HISTORIC AND DESIGN REVIEW COMMISSION

March 20, 2019

HDRC CASE NO: ADDRESS:	2018-636 419 W CEVALLOS
LEGAL DESCRIPTION:	NCB 63 BLK LOT W IRR 138.46 FT OF 2 & W IRR 26.89 FT OF 3(1.517 AC),
	P-101 (.346 AC),
ZONING:	IDZ, RIO-7E
CITY COUNCIL DIST.:	1
APPLICANT:	Sal Garcia/NRP Group
OWNER:	Peden Street Partners
TYPE OF WORK:	Construction of five, multi-family residential structures
APPLICATION RECEIVED:	March 01, 2019
60-DAY REVIEW:	April 30, 2019
CASE MANAGER:	Edward Hall

The applicant is requesting a Certificate of Appropriateness for approval to construct a multi-family residential development to feature one, 4 story building and four, 3 story buildings along W Cevallos and San Pedro Creek. The proposed development will feature a total of 323 residential units.

EXTERIOR ELEVATIONS

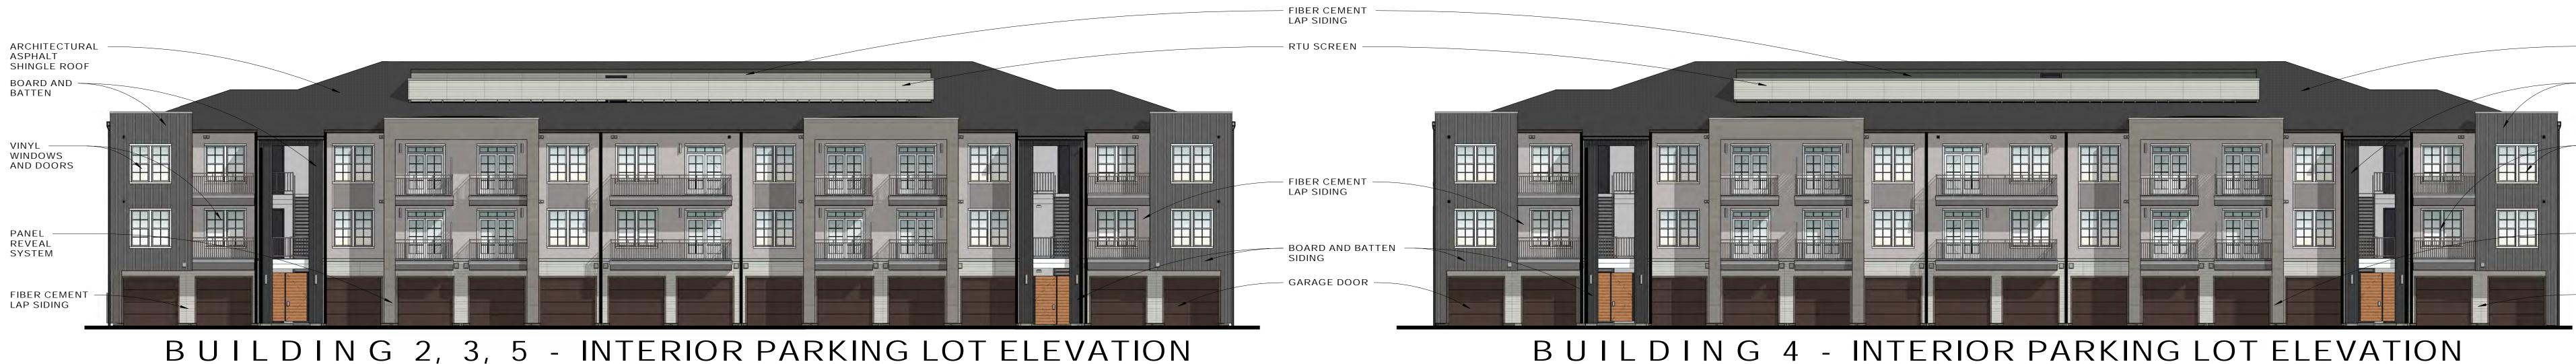
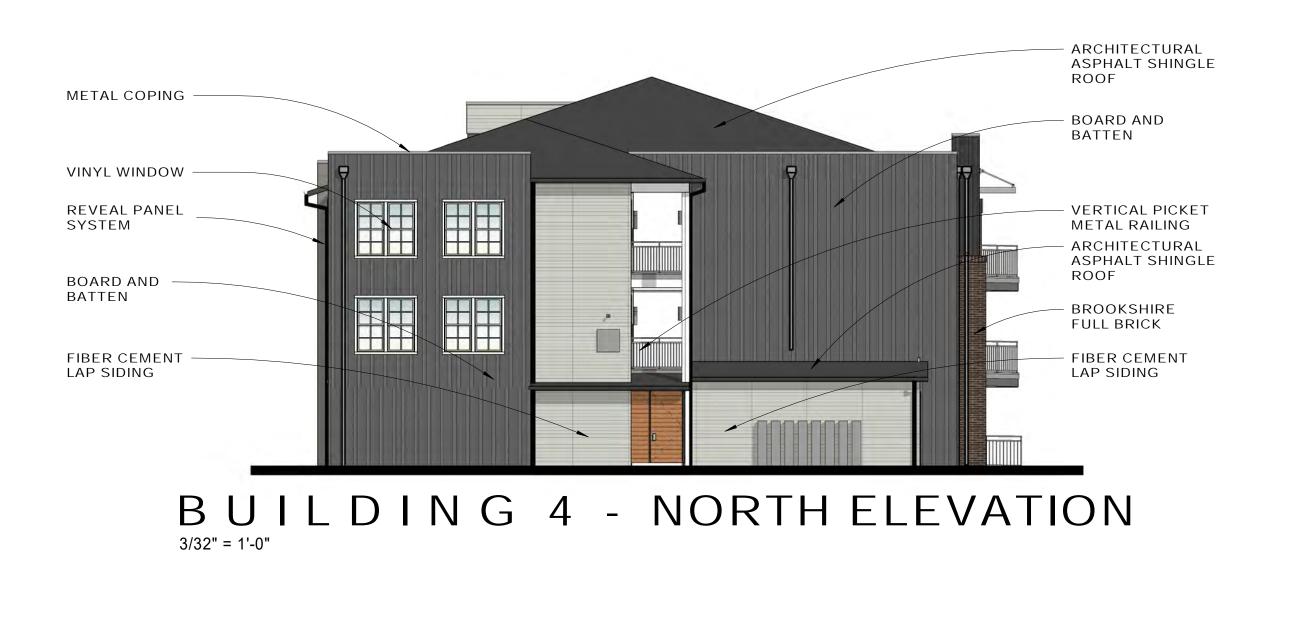
- n. MATERIALS The applicant has proposed materials that include asphalt shingles, board and batten siding, vinyl windows and doors, fiber cement lap siding, garage doors on interior elevations, iron spot thin brick, metal railings with vertical pickets, metal cladding, reveal panel systems and metal canopies. Staff finds the proposed materials to be appropriate. The applicant should ensure that the proposed vinyl windows feature a dark color and be recessed at least two inches within walls. Additionally, upon returning to the Commission for final approval, the applicant should provide details regarding proposed exposures and reveals of all cladding materials and submit specifications for the proposed windows and garage doors.

- i. That the applicant use windows that feature a dark color and are recessed at least two inches within walls.
 - ii. That the applicant provide specifications for all proposed materials.
